SR 525

MUKILTEO FERRY TERMINAL (PHASE 2) FERRY TERMINAL CONSTRUCTION

VOLUME 5 OF 8

VOLUME 5 SHEET INDEX

RFI 034 - Expansion Joint Vault

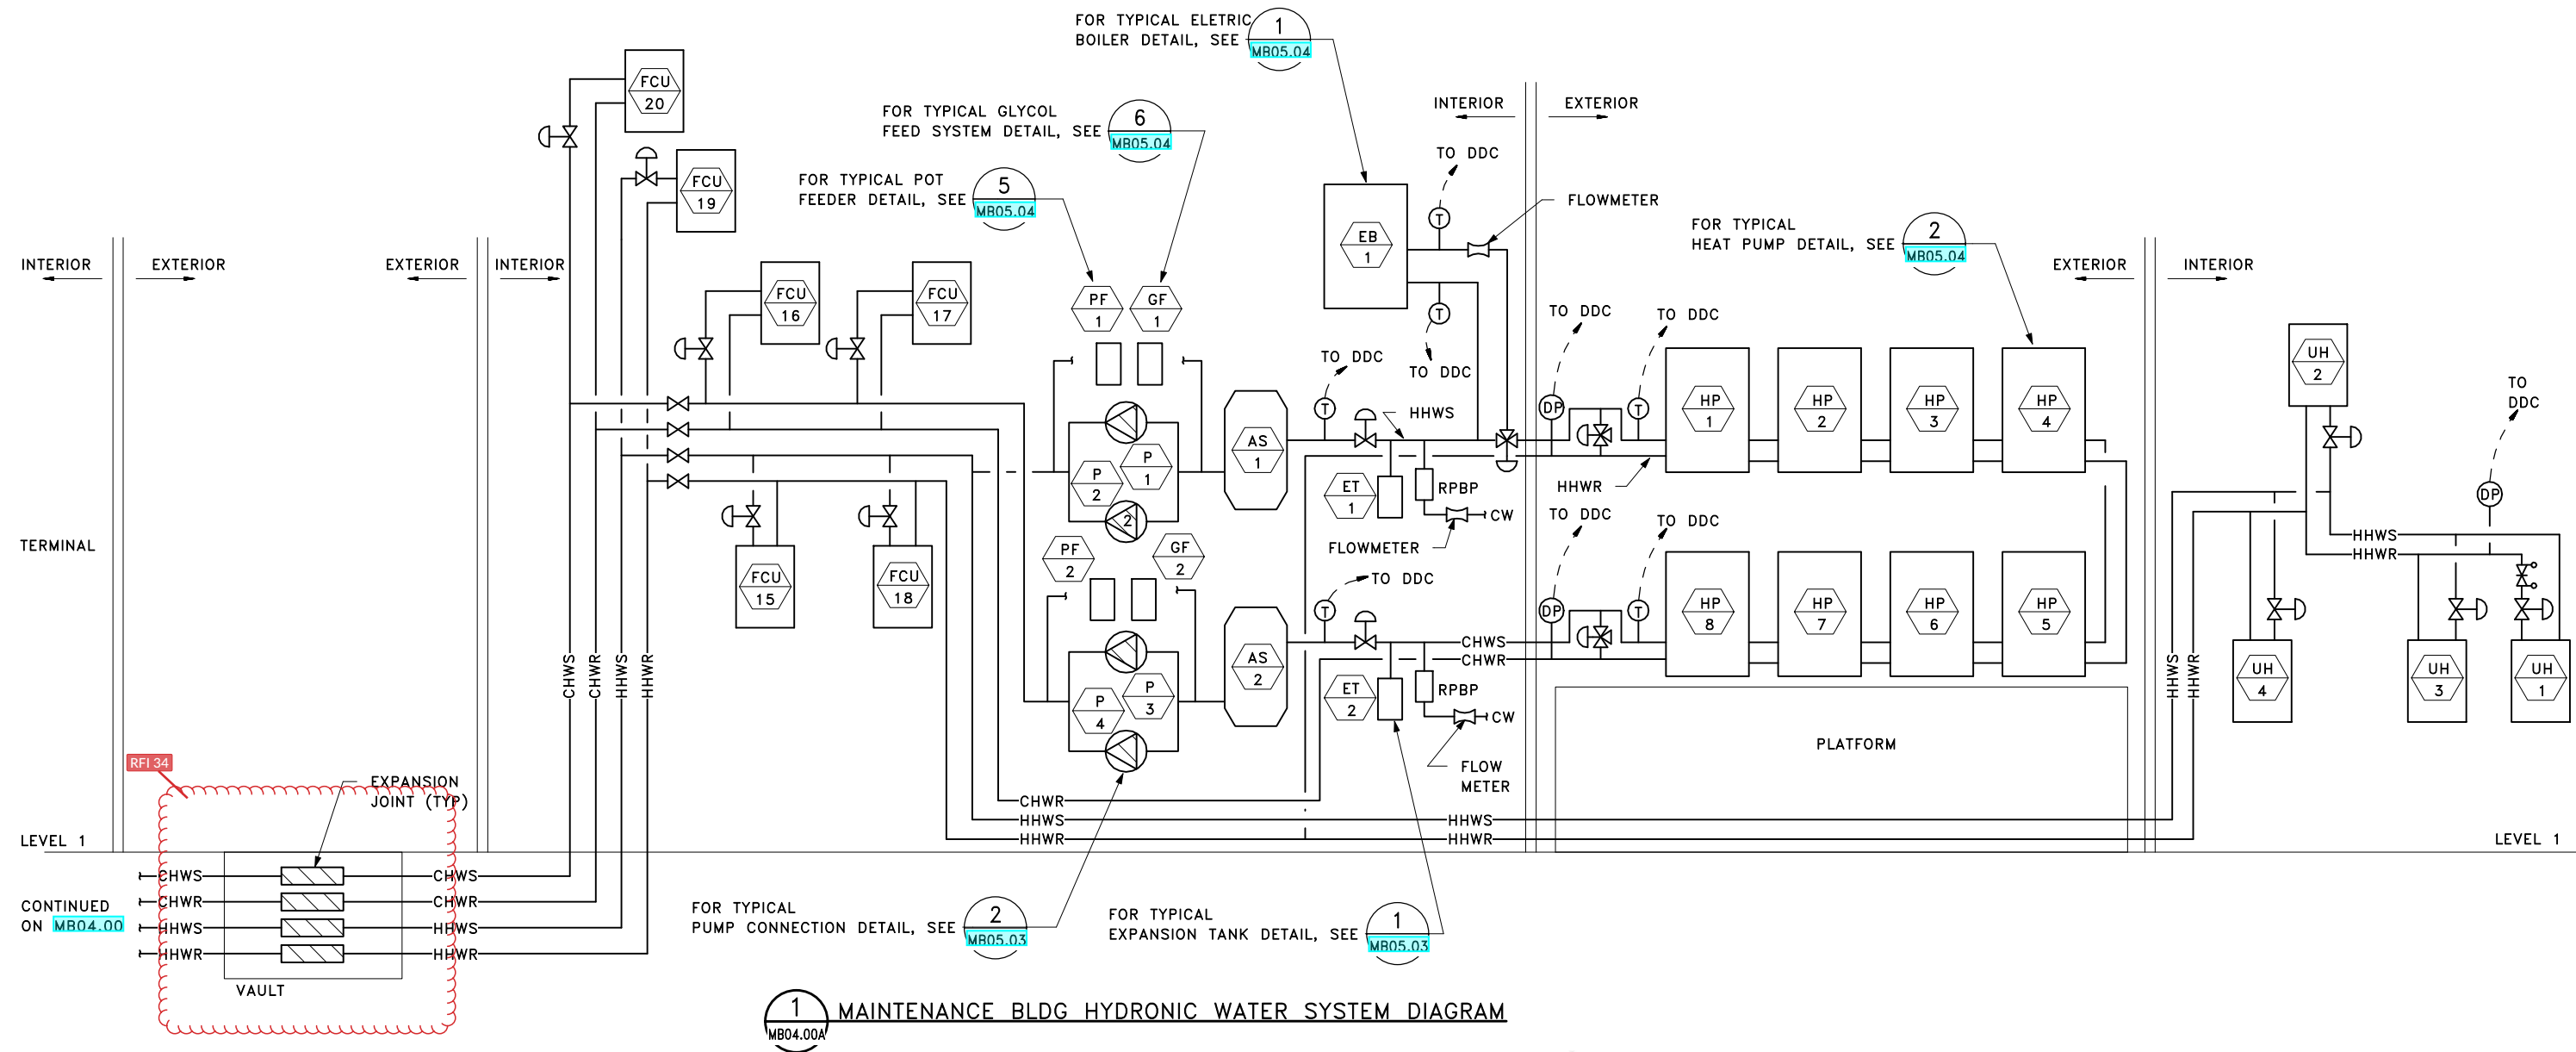
Drawing MB04.00A incorrectly calls out for a vault to be installed.
Contractor shall refer to drawing MB03.00 and specification section 23 05 00 for design information related to providing direct buried expansion joints.

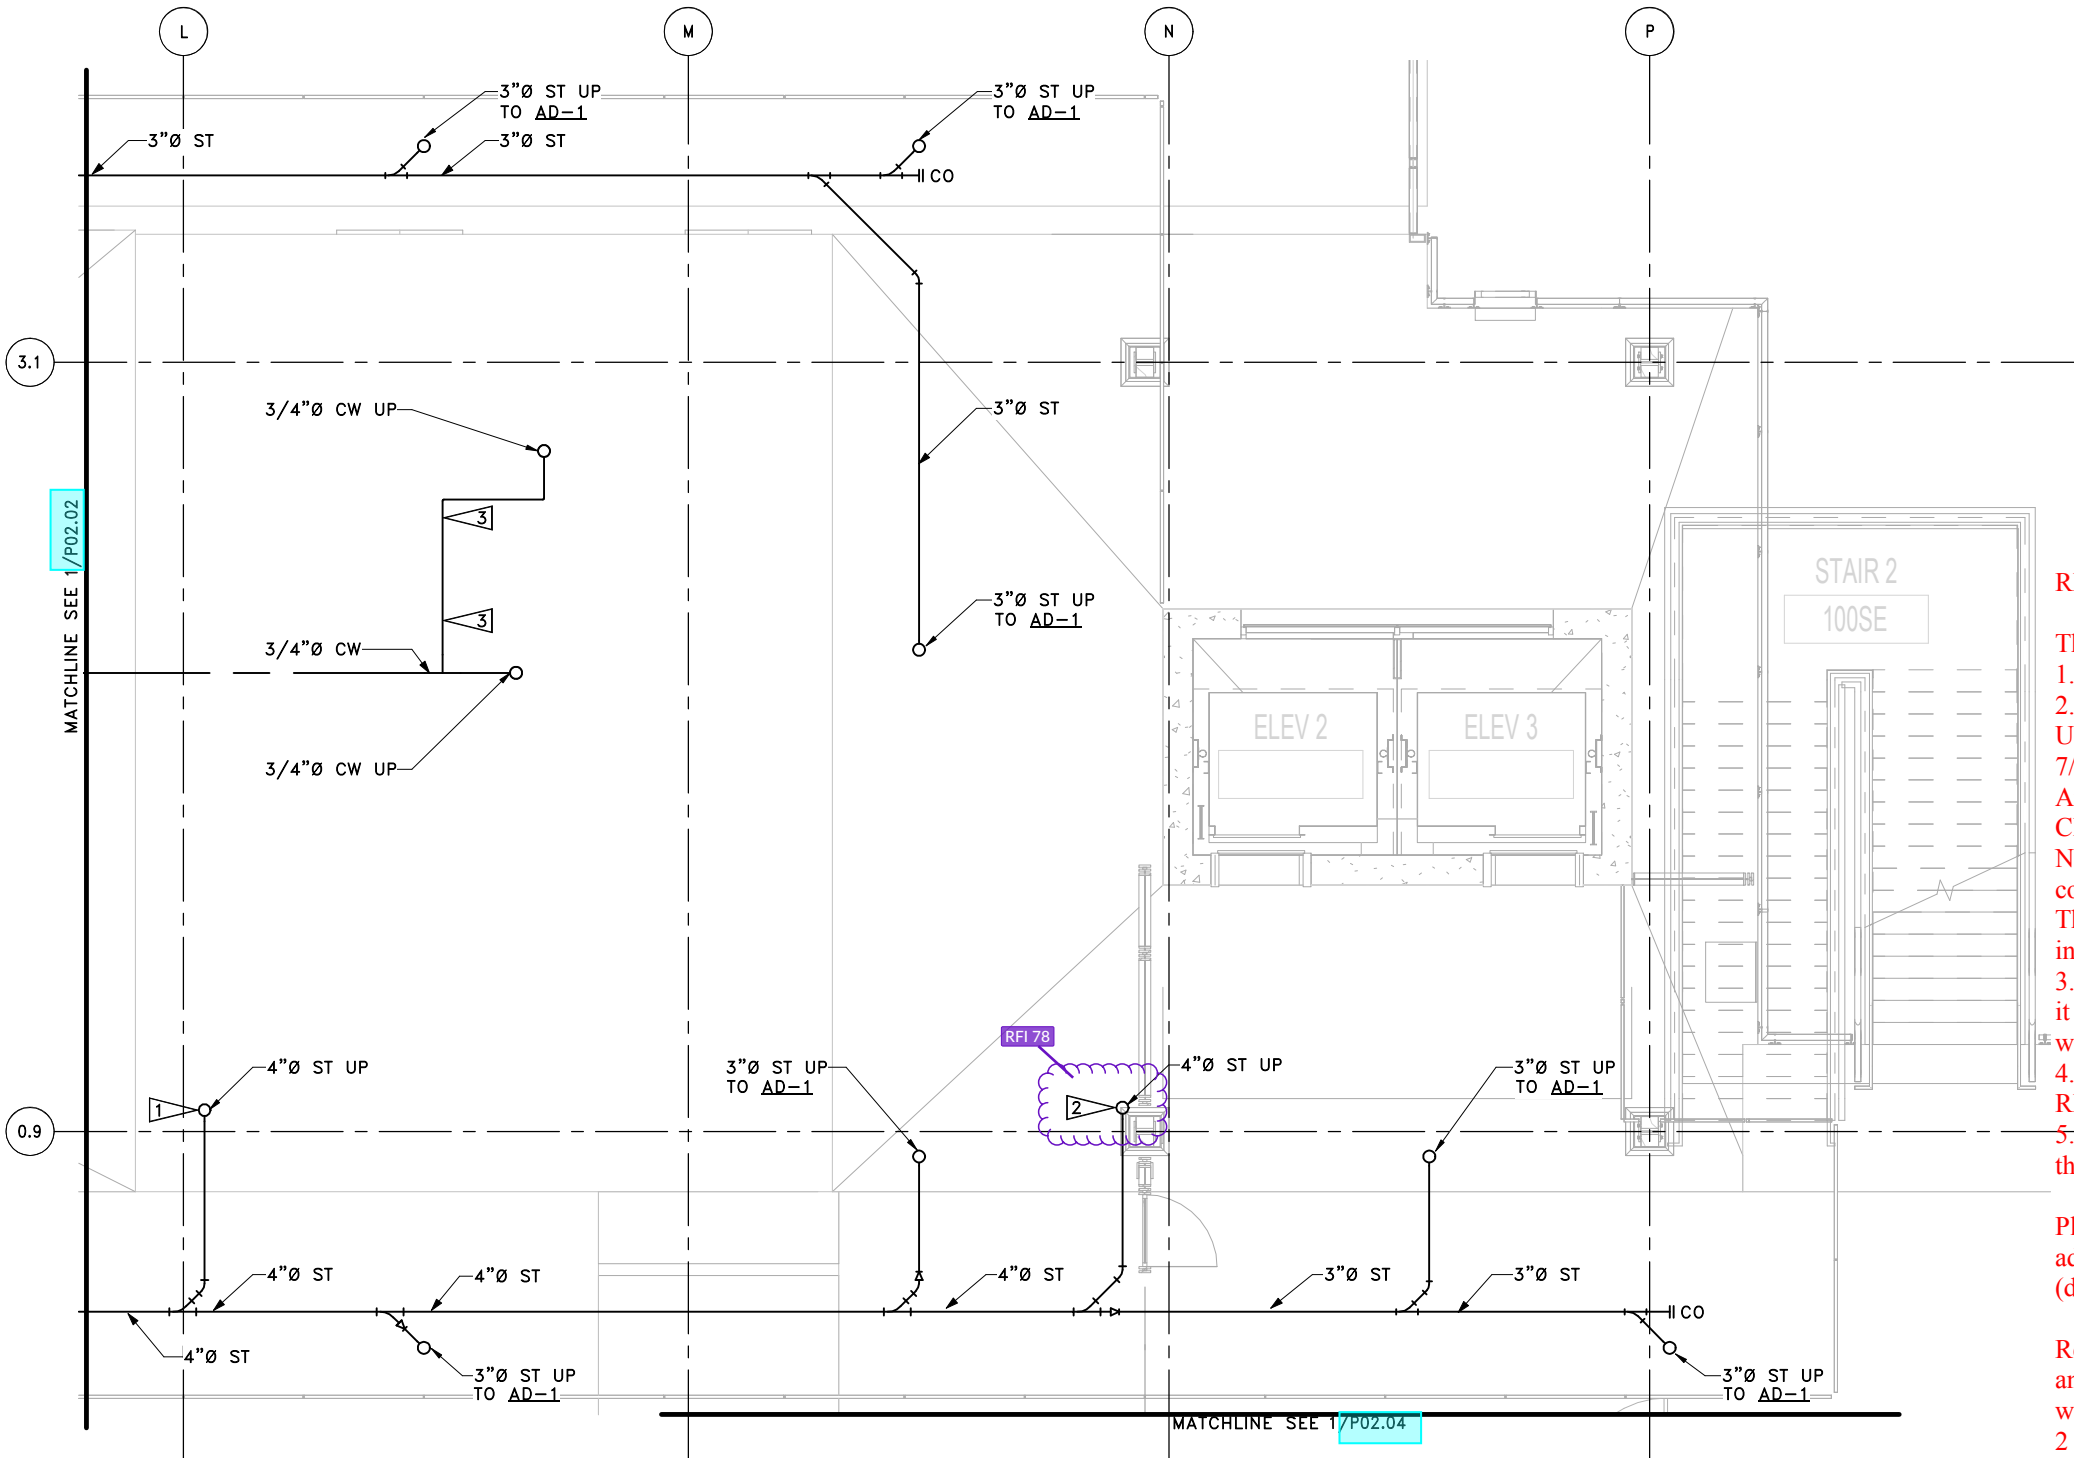
3. At Grids E & L, the rainwater leader needs to shift to the north ~1" so that it does not conflict with the beam flanges. Verify shift of rainwater leader with Arch.

RFI 120 - Sanitary Invert Elevation Conflict

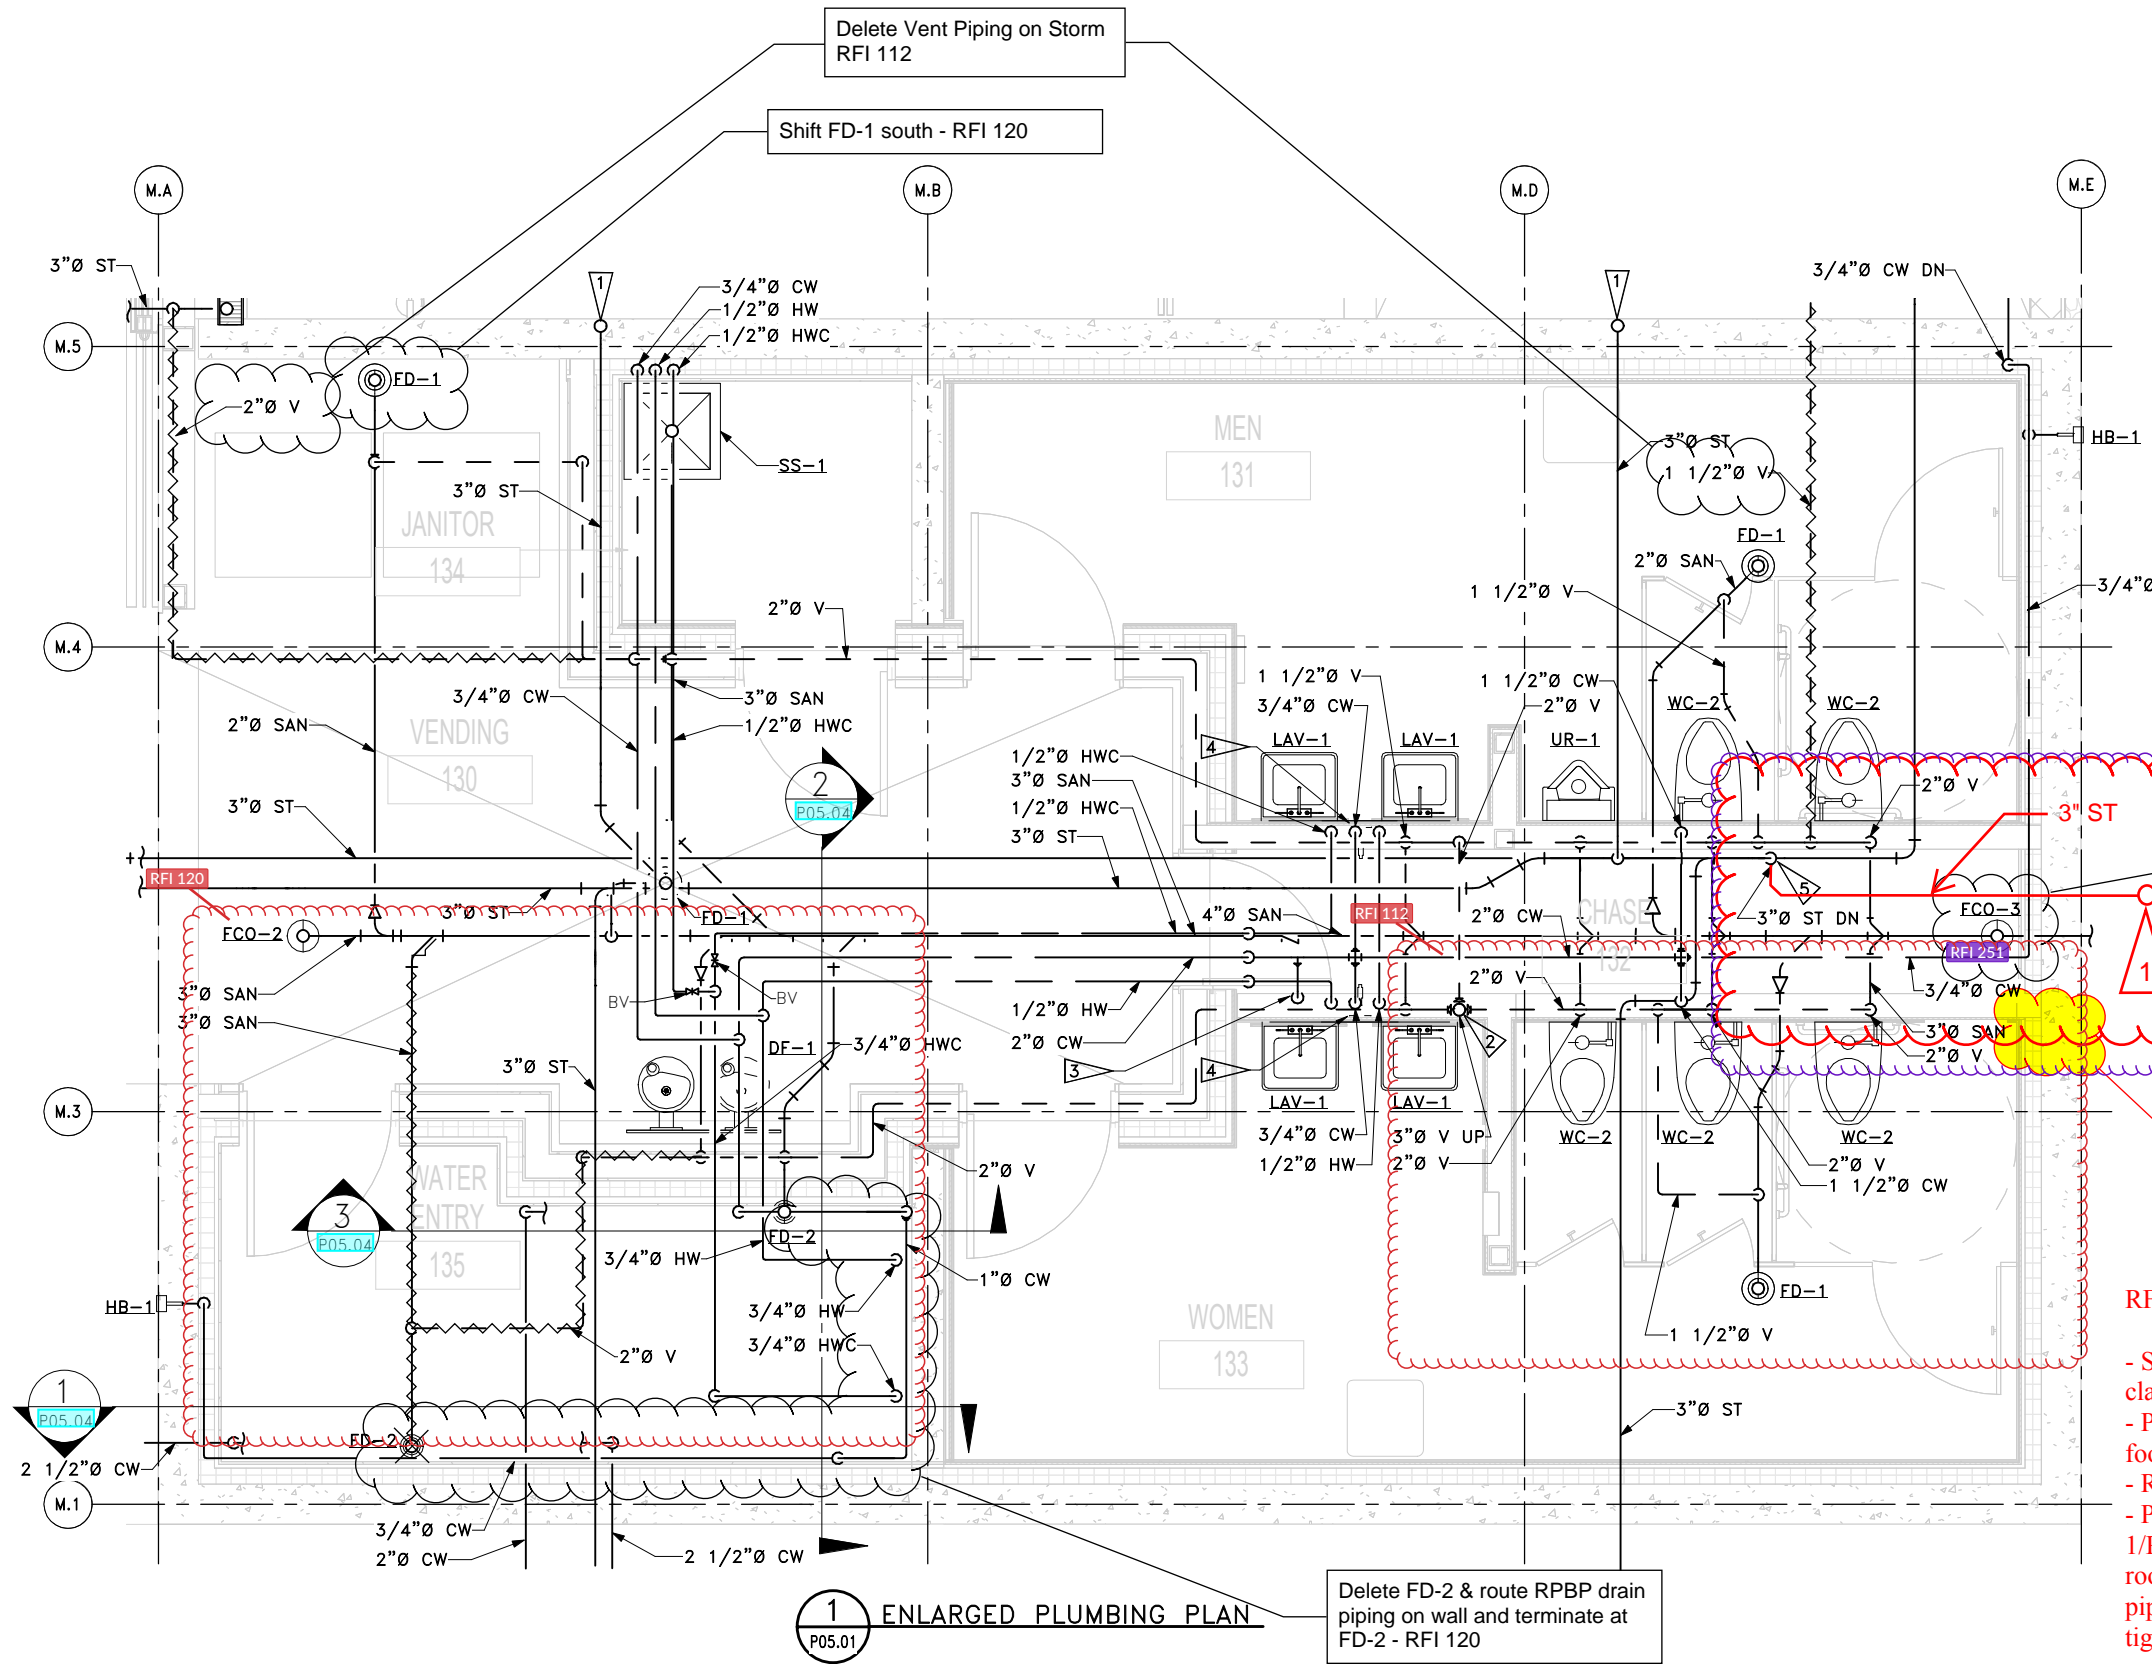
- Shift FD-1 south such that vertical pipe does not clash with building footer.
- Provide FCO-3 at building exterior to avoid footing. Provide with lock.
- Route piping tight to wall and terminate at FD-2.
- Provide 3" drain piping from RBPB (see 1/P05.04) to FD-2 located at northeast corner of room. Provide air gap between RBPB and 3" piping. Slope piping at 1/8" per 1'-0" and route tight to wall.
